DEPARTMENT OF NATURAL RESOURCES
DIVISION OF OIL, GAS AND MINING

May 25, 1989

RE: **North Fork Right Fork Miller Creek Breakout and Channel Disturbance Inspection, Cyprus-Plateau Mining Company, Starpoint Mine, ACT/007/006, Folder #5, Carbon County, Utah**

The attached map is a combination of the Wattis and Hiawatha USGS 7.5' Quadrangles.

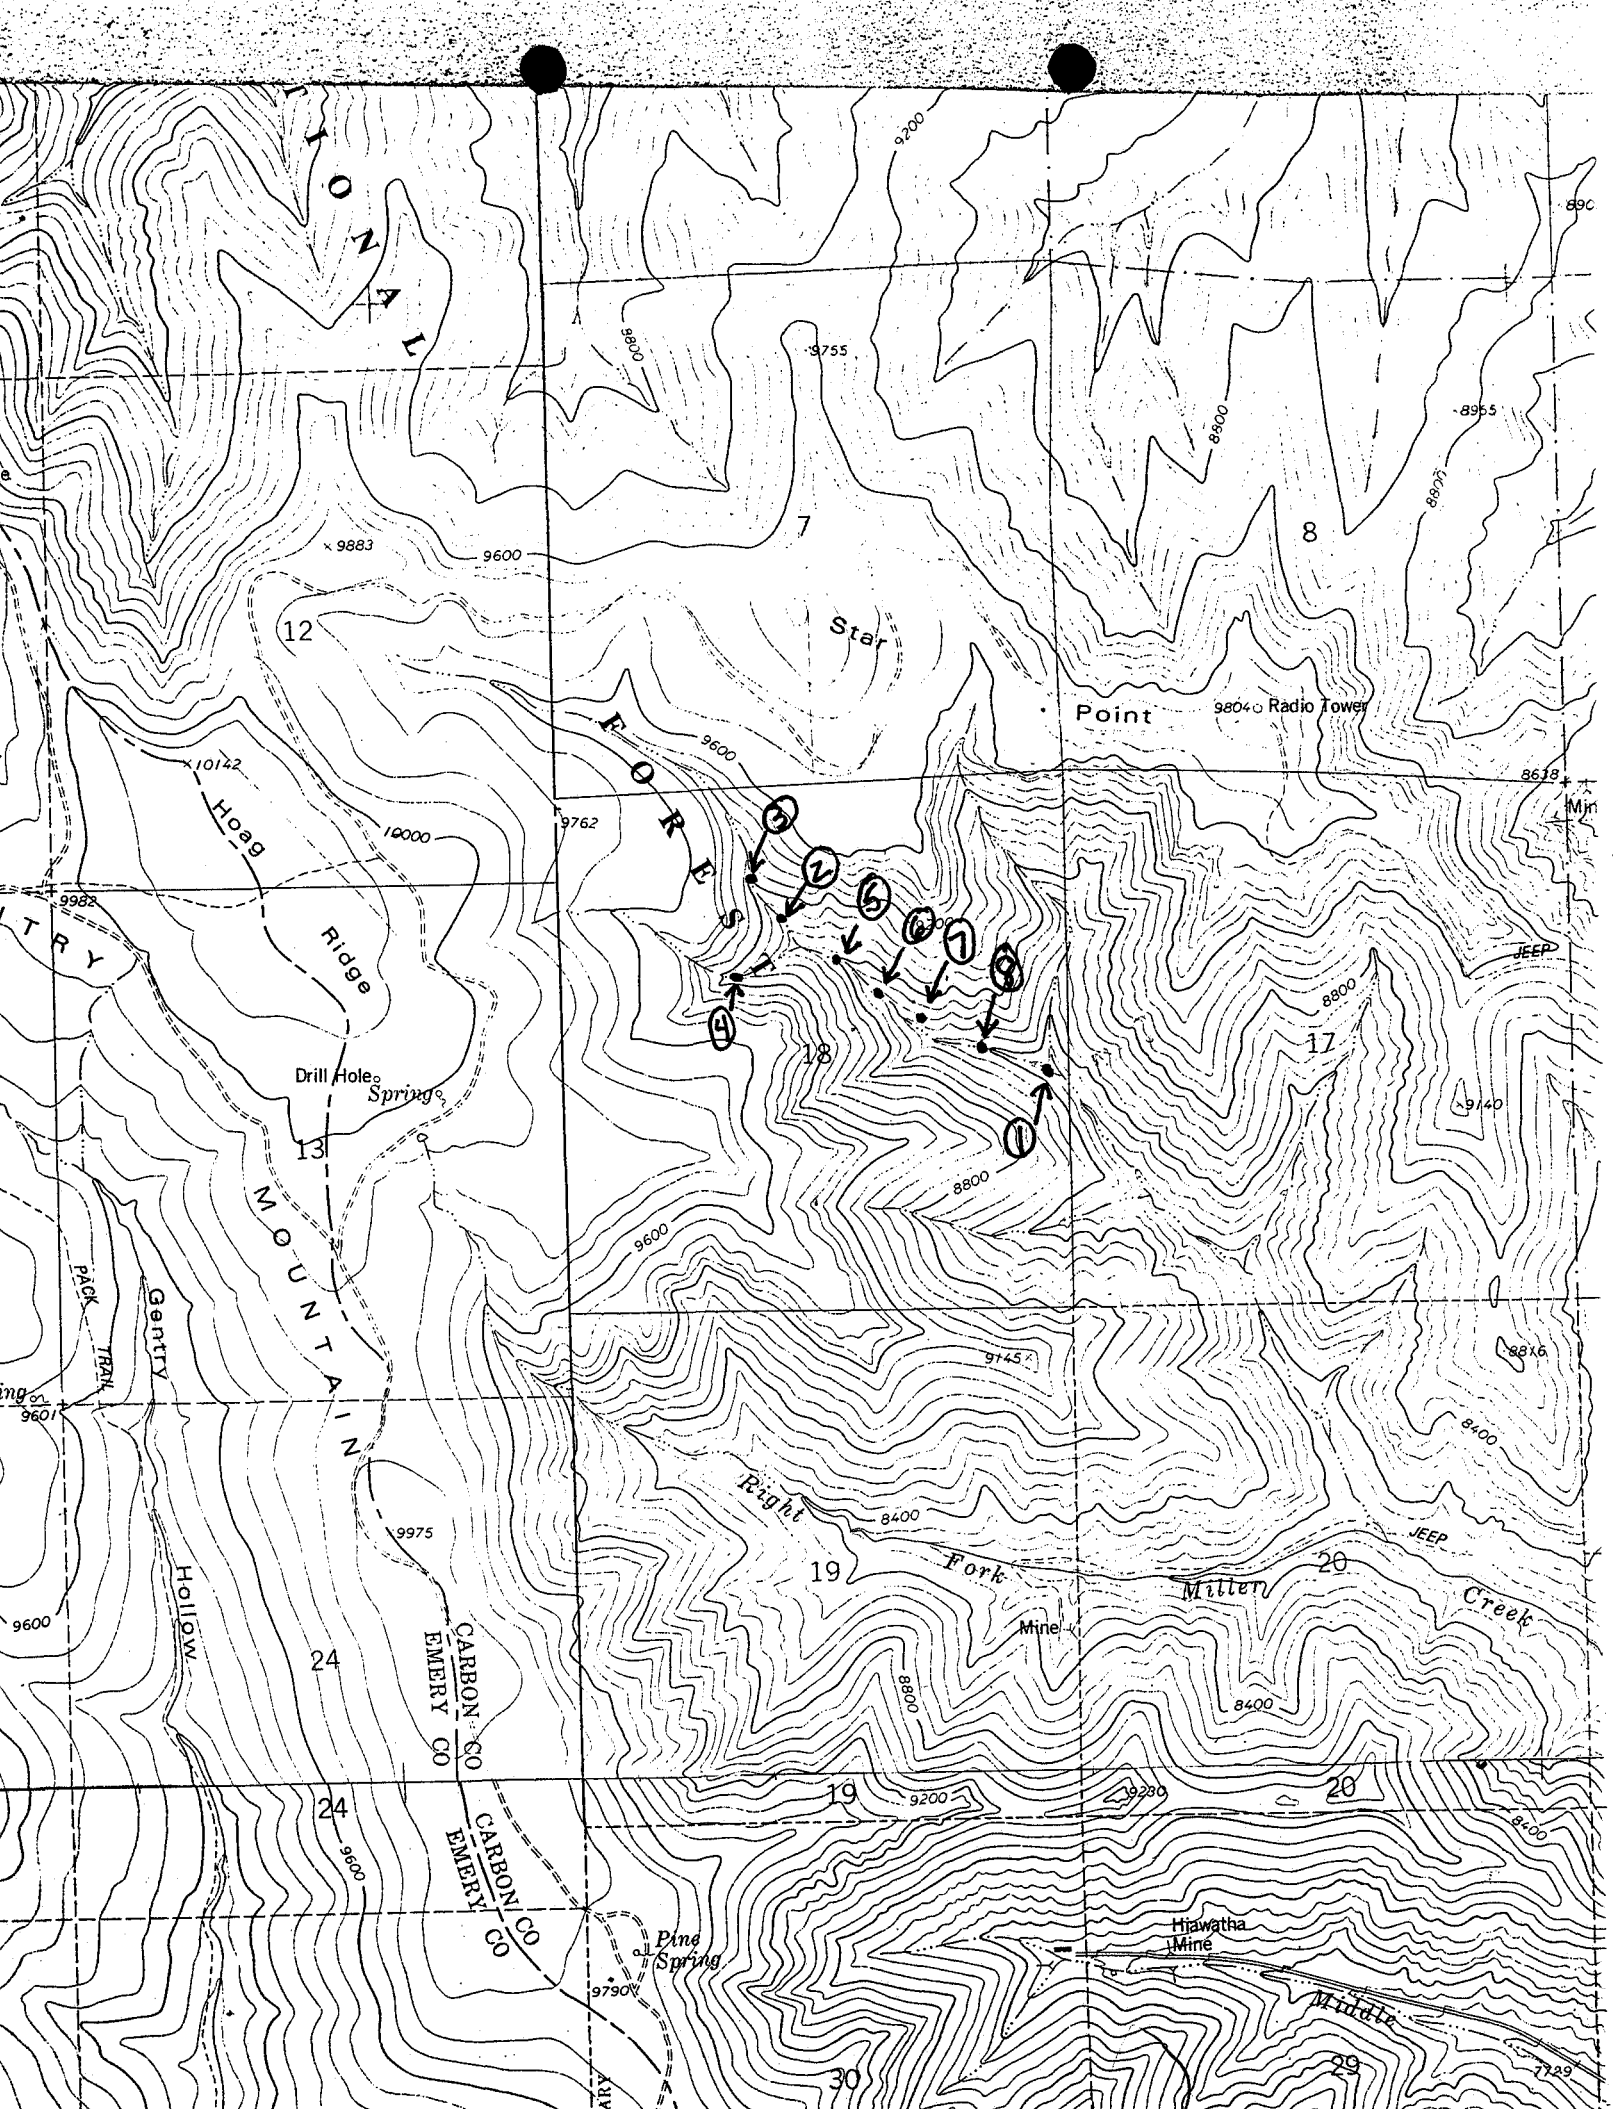
1. USGS, Cyprus-Plateau weir location. Flow = 12-15 gpm. This was the lowermost point inspected.

2. Recent surface buckling is evident in channel bedrock at a sandstone ledge. No apparent effect to the surface flow. Flow = 3-5 gpm.

3. This is the uppermost location of inspection on the Right Fork, up to a major sandstone outcrop and cliff former. Flow remains constant down to the second USGS monitoring well, 3-5 gpm (point 5). There was no more evidence of surface disturbance upstream from this point.

4. Definite channel disturbance. Upstream, flow = 20-25 gpm. Flow disappears in a 5-yard stretch. At the extreme lower end of flow, a small pool (0.50 ft^3) has developed. No surface flow exists below this point. The water appears to flow back dip.

This is the only portion of channel where it is obvious flow is lost.

5. USGS ground-water monitoring well. Flow above this area is 3-5 gpm. All is contributed by the right uppermost tributary. Surface conditions are very unstable in this area. Buckling of channel bedrock is evident. Nearly all flow is lost in a 15 yard stretch where side slope material has been downcast into the channel bottom. Flow below this point is < 1 gpm.

6. Lowermost USGS ground-water monitoring well. Surface disturbance is quite evident. Channel side slopes are very unstable. Flow is < 1 gpm.

7. Cyprus-Plateau Mining unintentional breakout. Instability is evident and surface flow is < 1 gpm.

8. Flow surfaces, approximately 12-15 gpm and remains constant down to the weir.

Schedule a team inspection to fully assess the surface disturbance and instability.

Remain in close consultation with the USGS for determining where surface flows are going; i.e., results of dye tracer tests.

If it is proven that stream water is being lost to the mine workings, instruct the operator to implement the approved mitigation plan.

Most feasible: Create a borehole from the mine to the stream to allow for gravity drainage if it is proven that stream flow is reduced by 50 percent or more for more than 30 days.

Do not allow any future longwall operations to undermine stream channels.
